January 2014
FL645A
NHTSA #13V-401
Transport Canada #13-300

Subject: Western Star Seat Belt Anchor Mountings

Models Affected: Specific Western Star 4900 vehicles with Stratosphere sleeper cabs manufactured May 27, 2008, through March 28, 2013.

Fig. 6, Seat Belt Installation

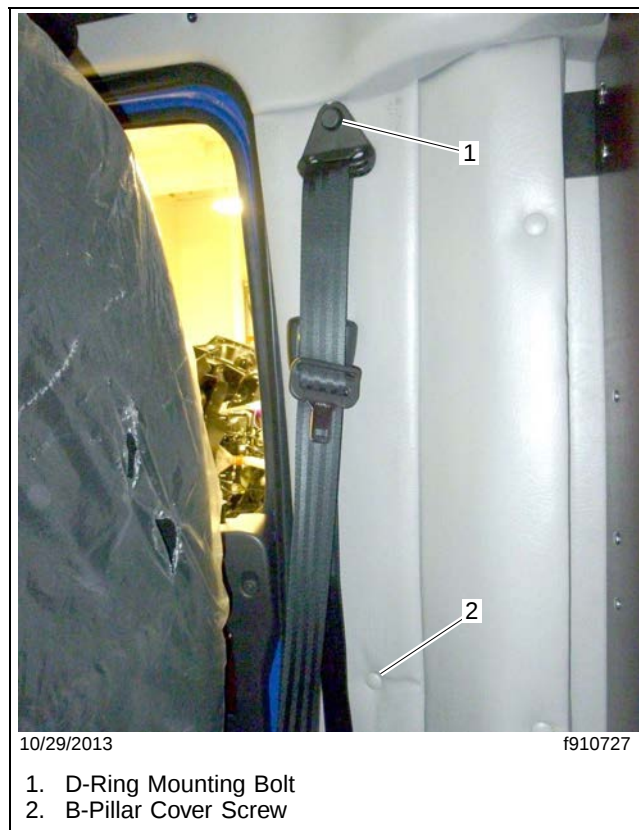
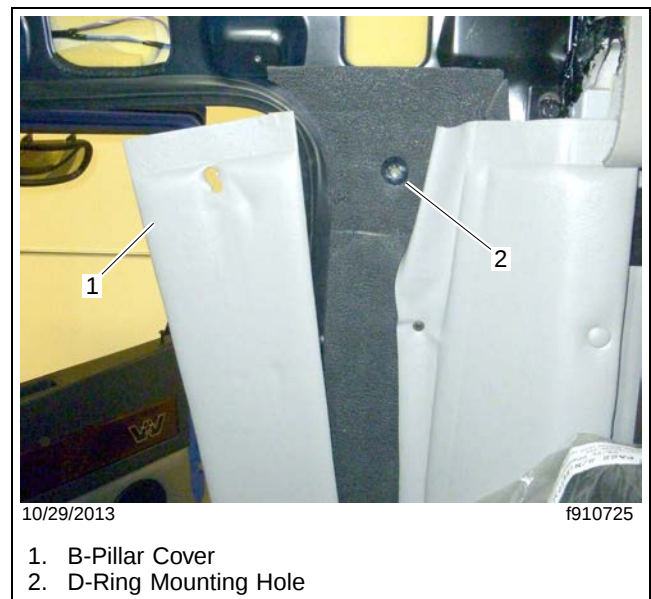
8. Remove the bolt that secures the seat belt D-ring to the B-pillar. See **Fig. 6**. Remove the seat belt from the B-pillar.
9. Remove the B-pillar cover screw (**Fig. 6**, item 2), then move the cover to the side. See **Fig. 7**.
10. Install the D-ring bolt through the anchor plate into the B-pillar. Align the plate so the top and bottom edges are horizontal. Then using it as a guide, cut a square out of the foam covering the B-pillar to create a mounting location for the anchor plate. See **Fig. 8**.
11. Remove the D-ring bolt, anchor plate, and square cut foam.

Fig. 9, Anchor Plate and Access Hole

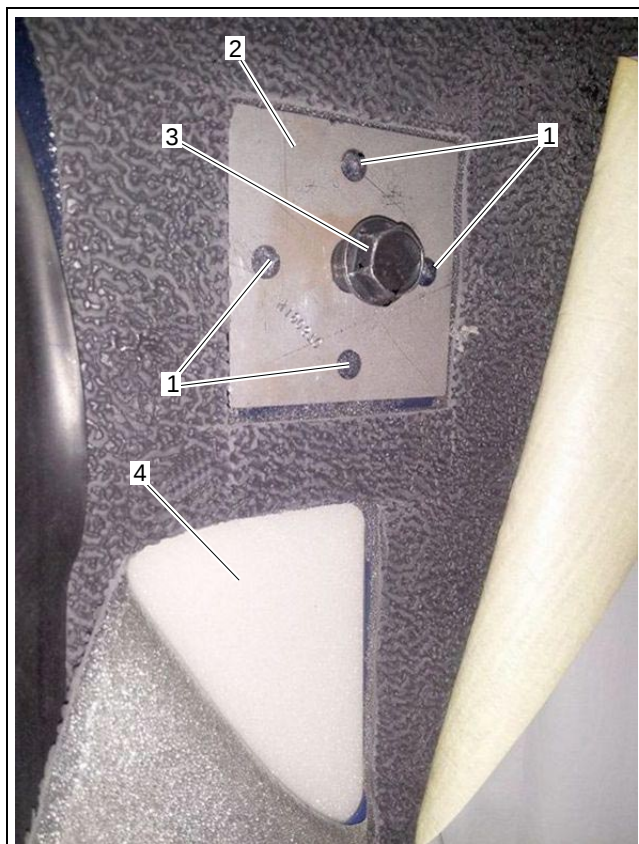
12. Locate the foam-covered access hole in the steel panel below the anchor plate, and cut the foam to gain access to the back of the plate. See **Fig. 9**.

IMPORTANT: For creating a bolt pattern for maximum strength, the anchor plate must be installed so the top and bottom edges are horizontal.

13. Insert the anchor plate and D-ring bolt into the newly cut square. Make sure the anchor plate is positioned with the top and bottom edges aligned horizontally. Then using it as a template, drill the four holes in the anchor plate into the B-pillar panel (and the nutplate on the back side of the panel). See **Fig. 9**
14. Secure the anchor plate with 1/4-inch bolts on the outside and the nuts on the back side of the B-pillar panel. Tighten the bolts 70 lbf·in (800 N·cm).
15. Remove the D-ring bolt.
16. Move the B-pillar cover back into position. Install the B-pillar cover screw.
17. Insert the D-ring bolt through the seat belt D-ring and place the spacer over the bolt. Apply Loctite 271 to the exposed bolt threads. See **Fig. 10**. Install the seat belt assembly on the B-pillar. Tighten the bolt 35 to 50 lbf·ft (47 to 68 N·m).
